SDIS1 HW Change Document

Product: SDIS1
Author: Vivian Kill-Tollnek, Emil Schuster, Tobias Cremer
Approver: CTC Advanced
Date: 28.09.2016
Version: v2.3
Status: Draft
Location: P:\SDIS1\05_SW08_Certification\TCF

1 Introduction of HW42

3.2.2.2 Schematics

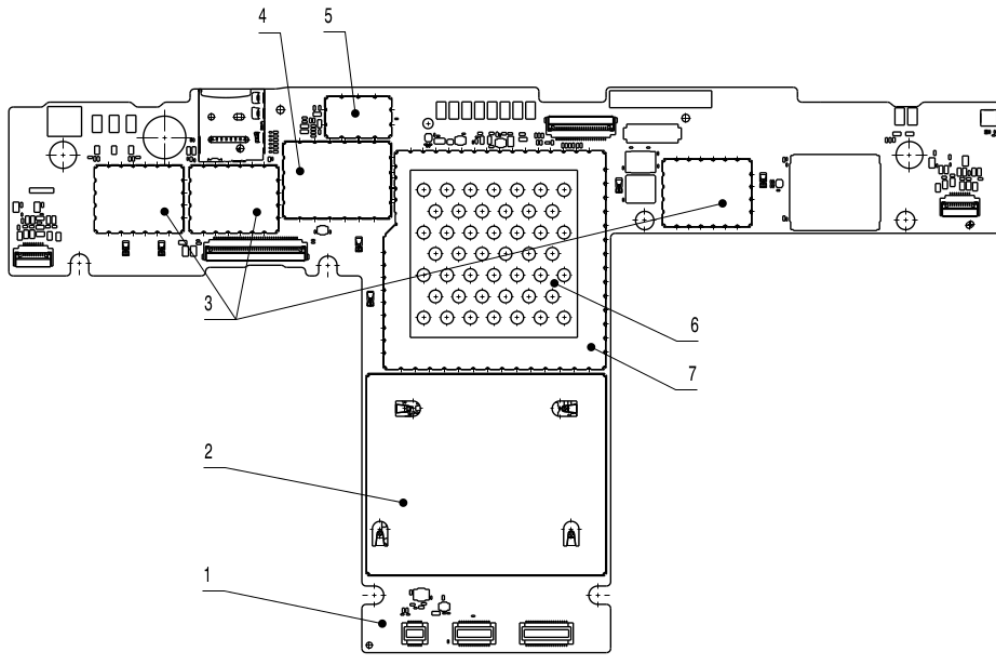
#	Affected Area	Change description	Expert opinion	Cetecom review
1	NFC	Removal of NFC functionality: Remove of NFC chip I9500 and related components; remove of NFC Antenna in Window Carrier Assy	no impact

The following components are set to not assembled
